New Albany Architectural Review Board Meeting Agenda
Wednesday, November 13, 2024 7:00 p.m.

New Albany Architectural Review Board
Monday, September 9, 2024 Meeting Minutes - DRAFT

**HAMLET AT SUGAR RUN
FINAL DEVELOPMENT PLAN & WAIVERS**

LOCATION: 29 S High Street (PID: 222-000026)
APPLICANT: ProSign Studio
REQUEST: Certificate of Appropriateness
ZONING: Historic Center
STRATEGIC PLAN: Village Center
APPLICATION: ARB-77-2024

PROPOSED PROJECTING SIGN - MAIN STREET

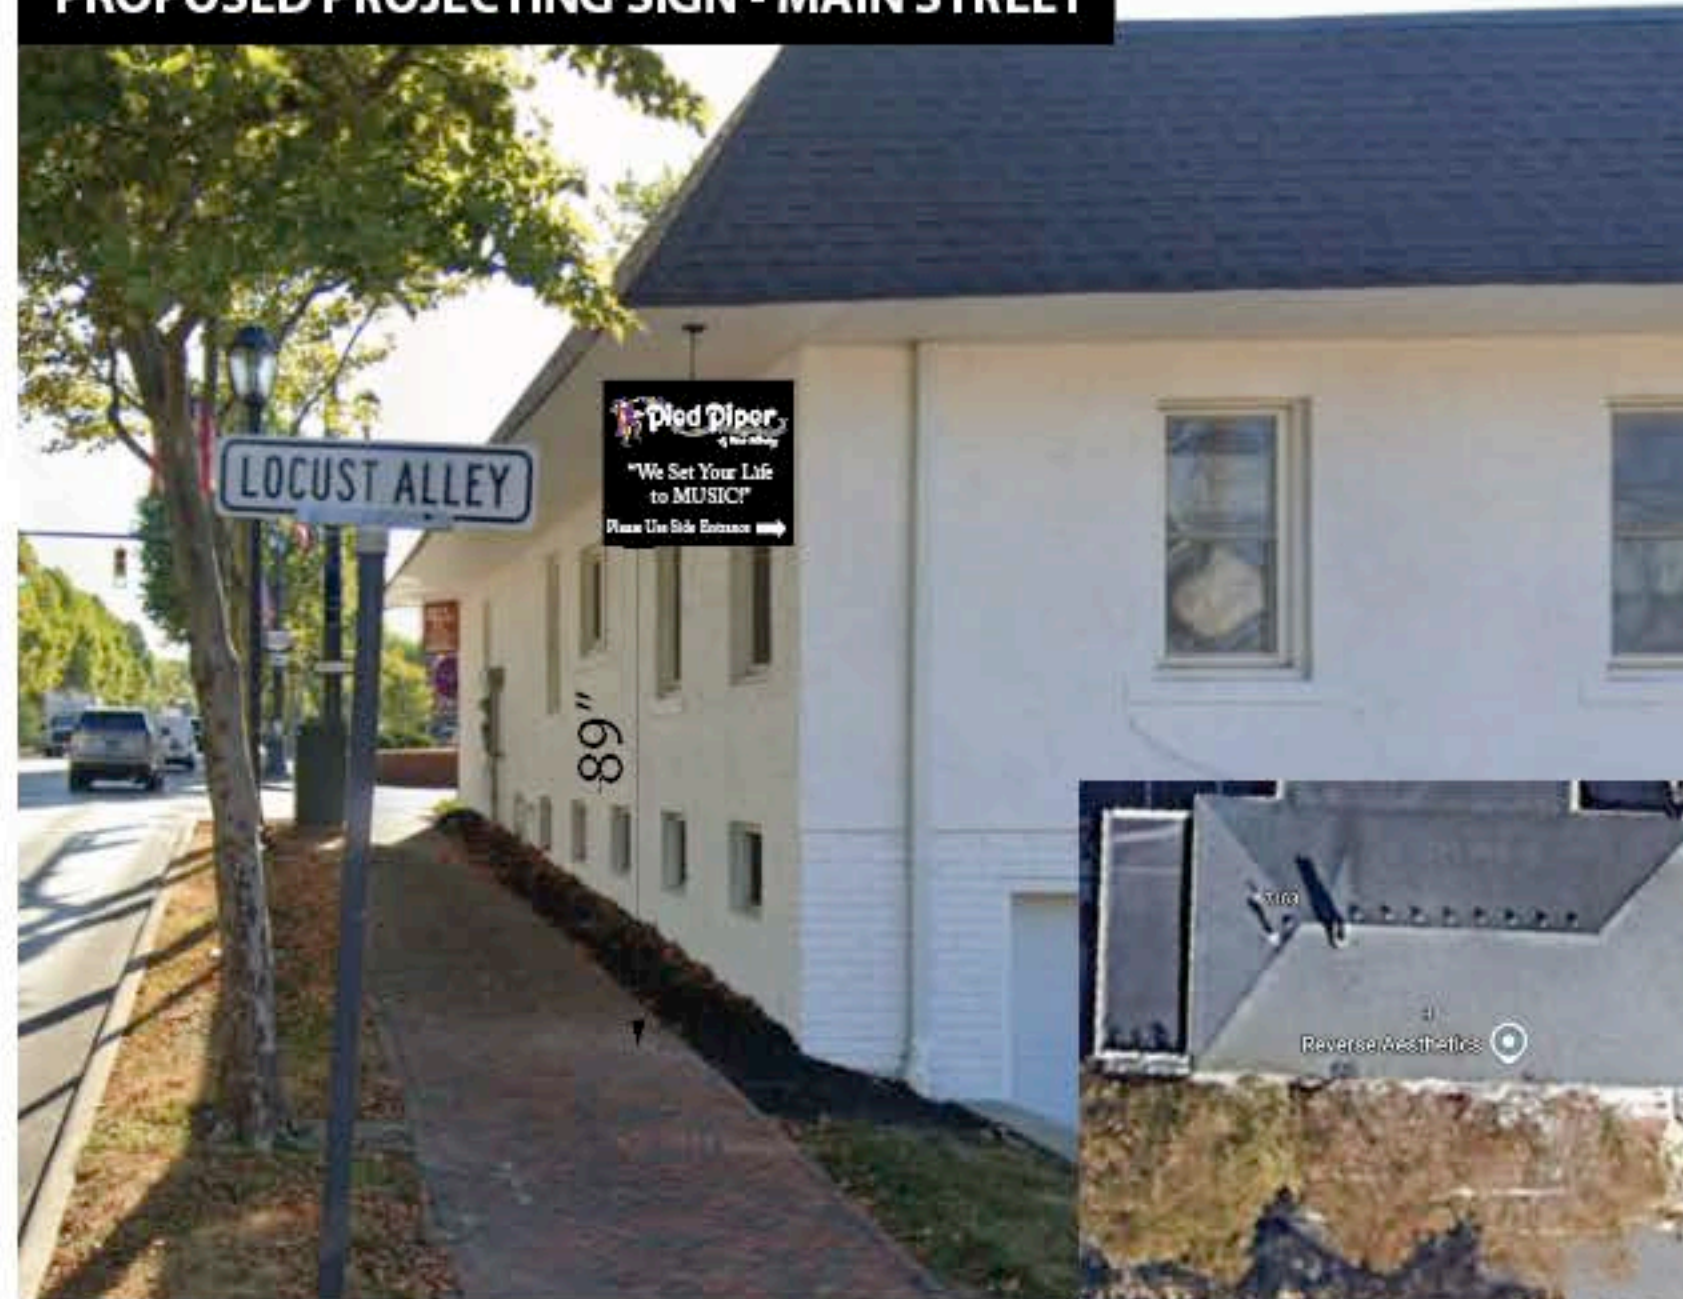
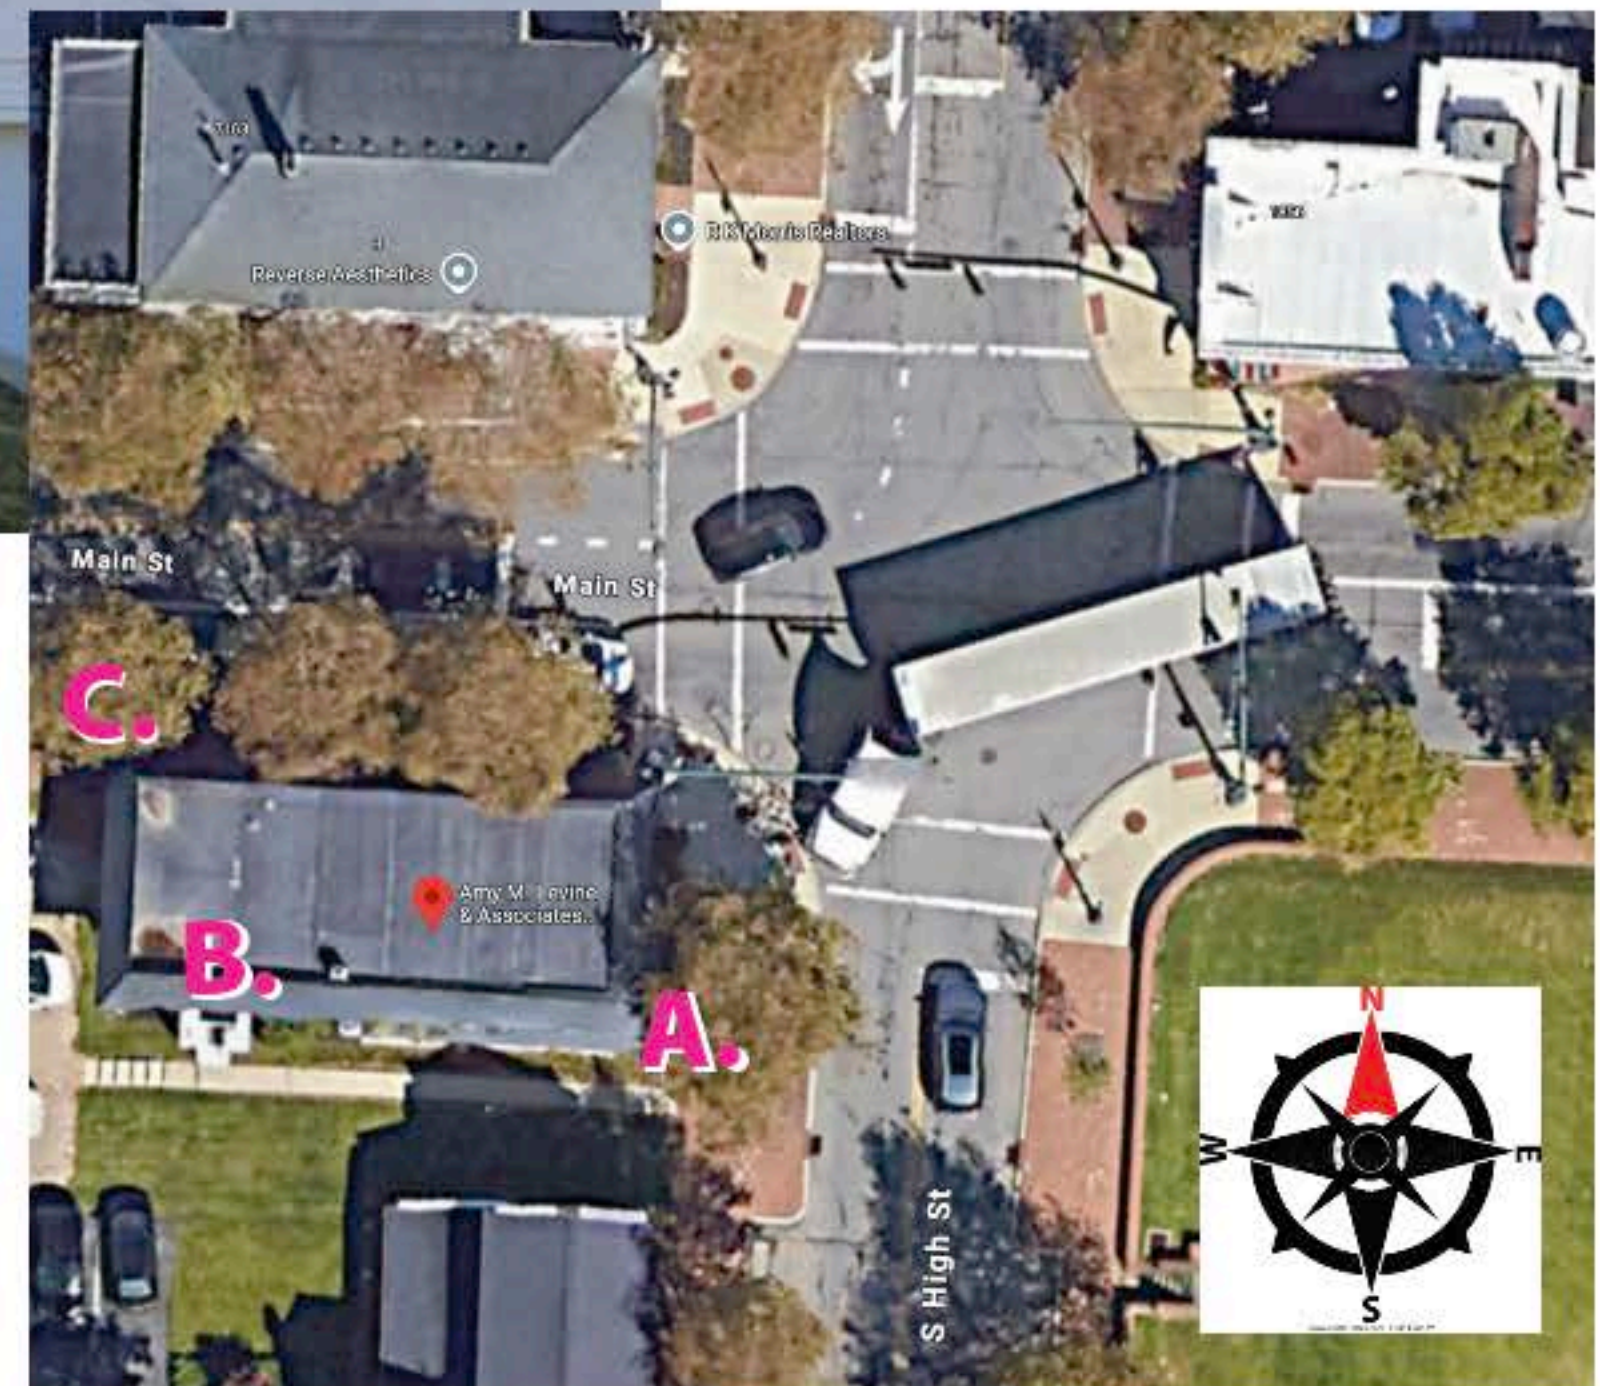
1. The sign is moved higher to meet the base of the roof in order to meet the minimum 8-foot clearance requirement, subject to staff approval.
